Product / Process Change Notification

N° 2020-016-A2 !! UPDATE !!

Capacity Extension for Dedicated OptiMOS™ Products in PG-TSDSON-8 Package at Tongfu Microelectronics Co. Ltd China

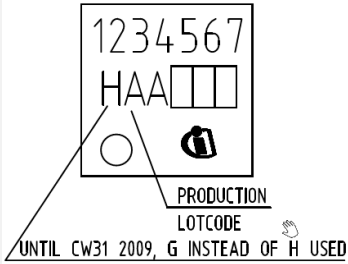
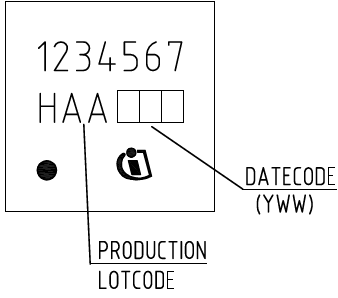
Description:	<u>Old</u>	<u>New</u>
Assembly and Final Test location	<ul style="list-style-type: none"> ■ Infineon Technologies Malaysia Sdn. Bhd., Melaka 	<ul style="list-style-type: none"> ■ Infineon Technologies Malaysia Sdn. Bhd., Melaka ■ Subcontractor Tongfu Microelectronics Co. Ltd.,China
Marking on device	<ul style="list-style-type: none"> ■ Infineon Technologies Malaysia Sdn. Bhd., Melaka 	<ul style="list-style-type: none"> ■ Infineon Technologies Malaysia Sdn. Bhd., Melaka ■ Subcontractor Tongfu Microelectronics Co. Ltd.,China
